ENVIRONMENTAL ENGINEERING SURVEY

NAVAL COASTAL SYSTEMS CENTER

PANAMA CITY, FLORIDA

OCTOBER 1980

SKETCH OF LATENT DISTRIBUTION
ARMS

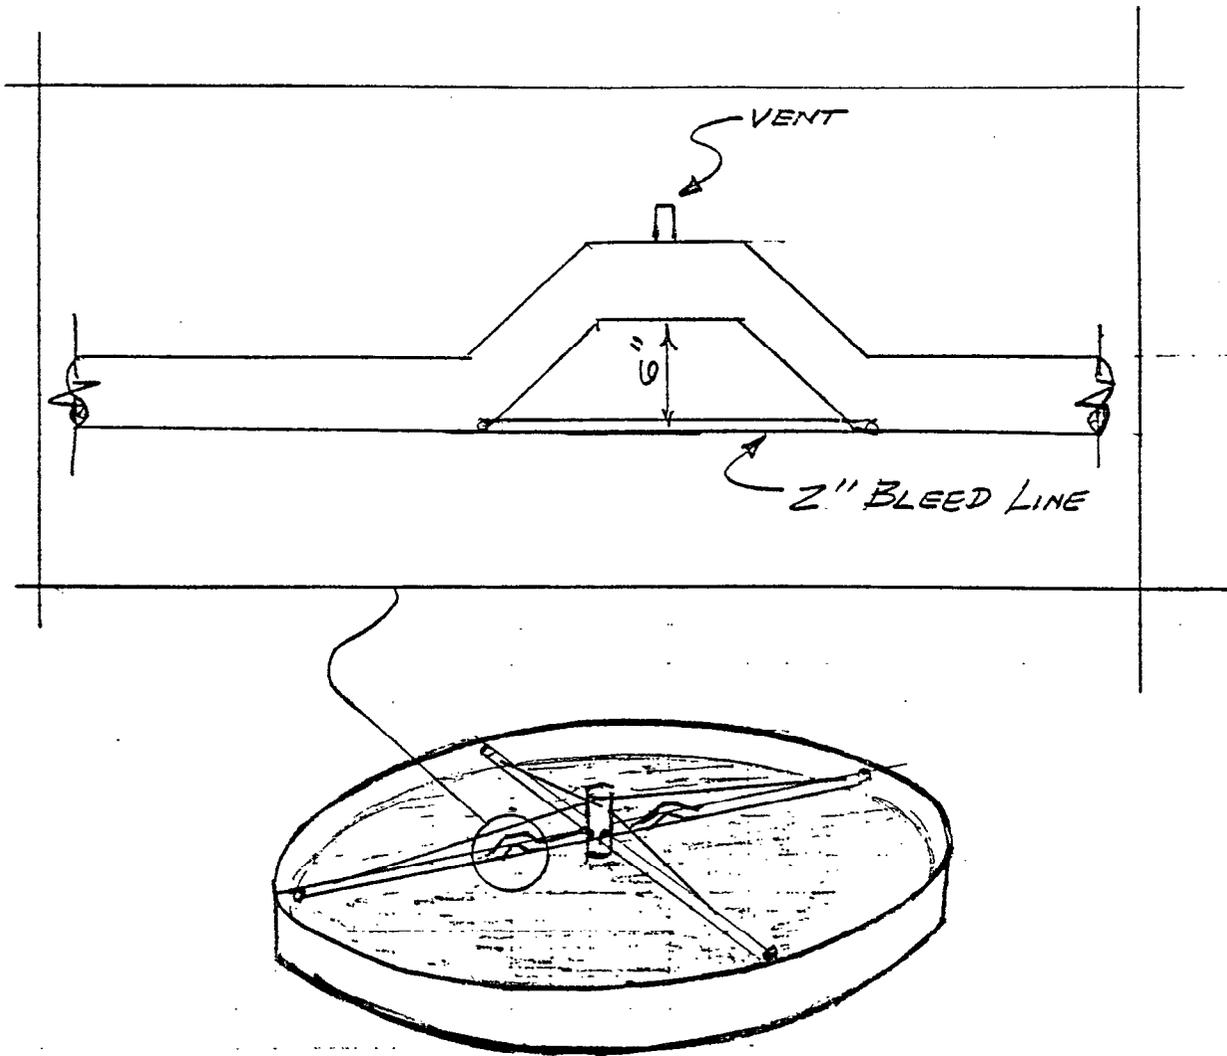
The trickling filter is located beneath several large live oak trees that continually drop small leaves into the filter dosing chamber. The leaves are carried with the effluent to the filter distribution arm where the leaves clog the distribution nozzles. This problem could be eliminated by the placement of a screen over the open top of the dosing box. The trickling filter has four distribution arms though only two are being used. The two arms are adequate for normal flow but on occasional peak flows the dosing box overflows before the influent can be distributed by the two arms. If all four arms are used during normal flow, there is insufficient velocity at the discharge nozzles to cause the arms to rotate.

The operation of the filter could be improved by modifying two of the distribution arms so that they will automatically become active when flow peaks. An inverted trap with a six inch freeboard should be installed in the normally inactive distribution arms. A sketch of this configuration is shown as Appendix B. The trap freeboard should be set just below the dosing box overflow elevation.
